NO. SI D4-184

Technify Motors Service Bulletin SB TMG 125-1020 P1
ATA-Code: 72-00

Service Bulletin No. / Date: SB TMG 125-1020 P1, Initial Issue / January 27, 2016

Subject: Gearbox Oil Leak Inspection

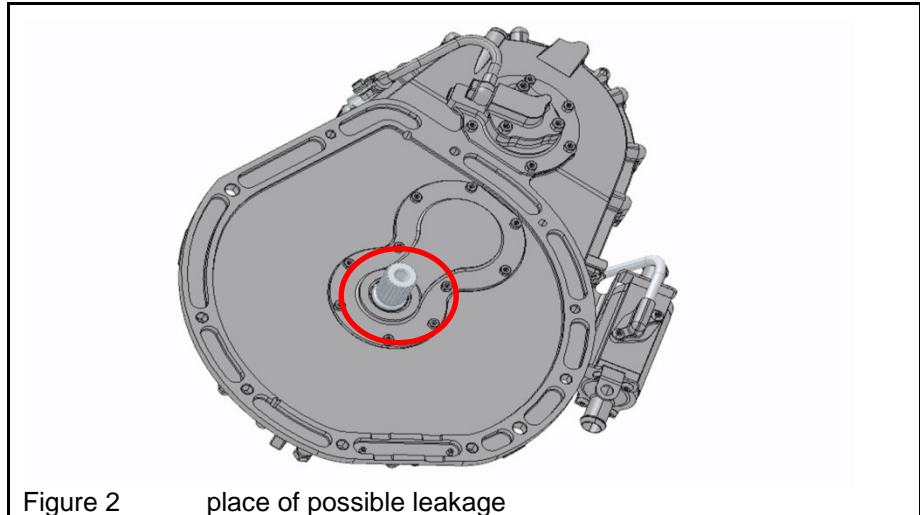
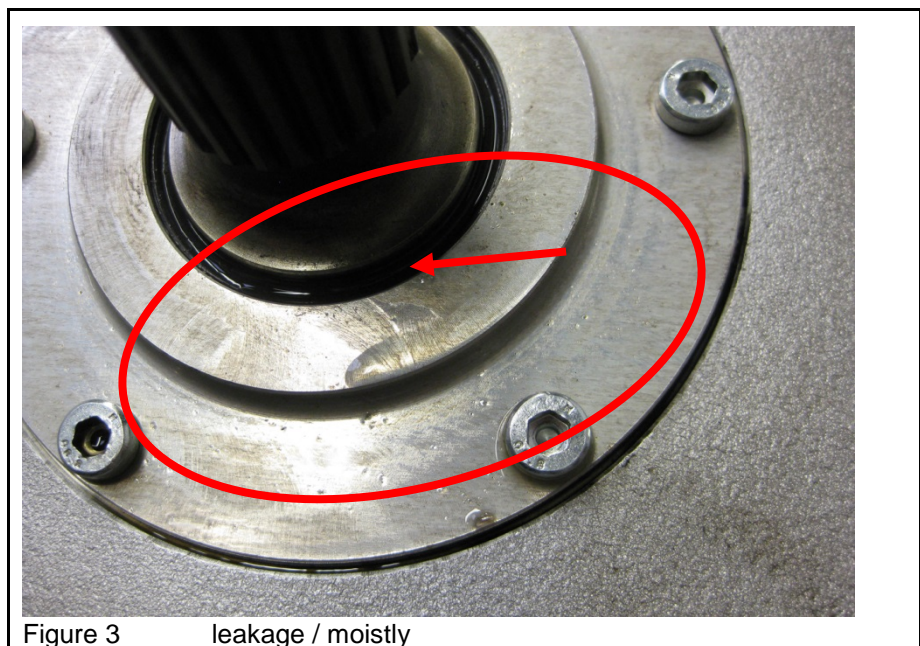
Reason: Radial shaft sealing ring may not seal properly due to an improper lapped gearbox drive shaft. This can lead to an oil leak and a slipping clutch and finally to a loss of power.

- Remove the gearbox and replace the clutch by dual mass flywheel in accordance with RM-02-02, Chapter 72-10.18, Issue 3, Revision - or later approved revisions.
- Inspect the gearbox, check the rear radial shaft sealing ring on the gear shaft for oil leakage and moisture, see Figure 2 and Figure 3.

- If there is a leakage or moisture, see Figure 3, replace the gearbox.

◆ Note: The clutch has to be replaced by the dual mass flywheel in each case.
